Report: Deficiency Report
Function: Test, Adjust, & Balance
Date: 02/17/2026
Completed By: National TAB

02-16-26 WHATABURGER #1687 LUTZ, FL

Project: 02-16-26 WHATABURGER #1687 LUTZ, FL

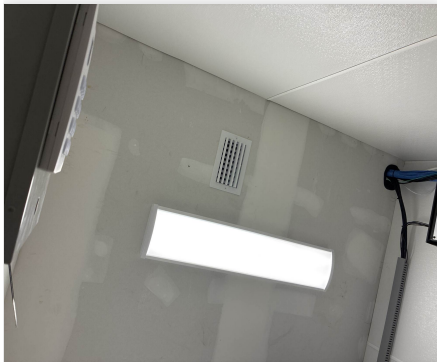
Issue Name : Additional Diffuser - RTU 3 office
Description : An additional diffuser was installed in office. There was an existing supply flex duct run blowing above ceiling in which the MC tapped into. Currently, damper is fully closed and grill reads 75 CFM. Unable to balance without a CFM target. Recommend engineer review.
Created By : National TAB **Assigned To :** National TAB - Will Turnbough
Status : Open
Priority : Urgent **Asset Tag :**
Originated Date : 02/19/2026 - Jackson Gunnels - National TAB

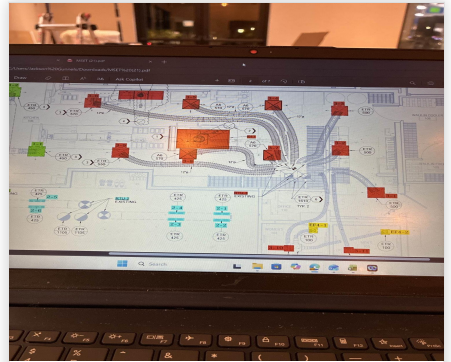
Issue Name : Exhaust fans - Incorrect Locations
Description : Exhaust fans are mounted on wrong curbs. Unable to balance fans in current state. EF-1 (larger fan) also leaks around curb.
Created By : National TAB **Assigned To :** National TAB - Will Turnbough
Status : Open
Priority : Urgent **Asset Tag :**
Originated Date : 02/19/2026 - Jackson Gunnels - National TAB

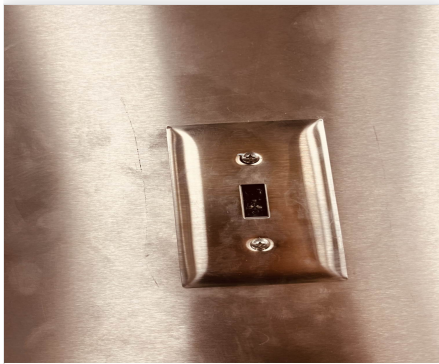
Issue Name : High Humidity Recorded
Description : Space is very humid, measured at %68 relative humidity. NTi noticed units were not cooling the space effectively. Cleaning evaporator coils may improve their efficiency.
Created By : National TAB **Assigned To :** National TAB - Will Turnbough
Status : Open
Priority : InfoOnly **Asset Tag :**
Originated Date : 02/19/2026 - Jackson Gunnels - National TAB

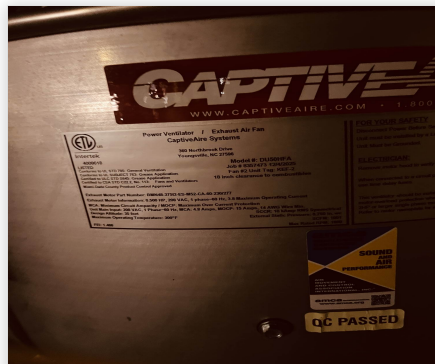
Issue Name : Hood 2 power switch
Description : Hood 2 power switch is damaged.
Created By : National TAB **Assigned To :** National TAB - Will Turnbough
Status : Open
Priority : Low **Asset Tag :**
Originated Date : 02/19/2026 - Jackson Gunnels - National TAB

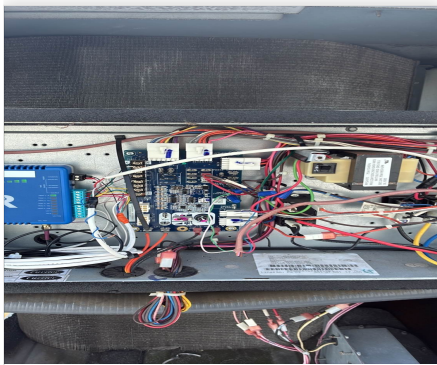
Issue Name : Restroom supply dampers
Description : Parallel blade dampers installed in restroom supply only reduce airflow by half when fully closed, recommend OBDs be installed.
Created By : National TAB **Assigned To :** National TAB - Will Turnbough
Status : Open
Priority : Urgent **Asset Tag :**
Originated Date : 02/19/2026 - Jackson Gunnels - National TAB
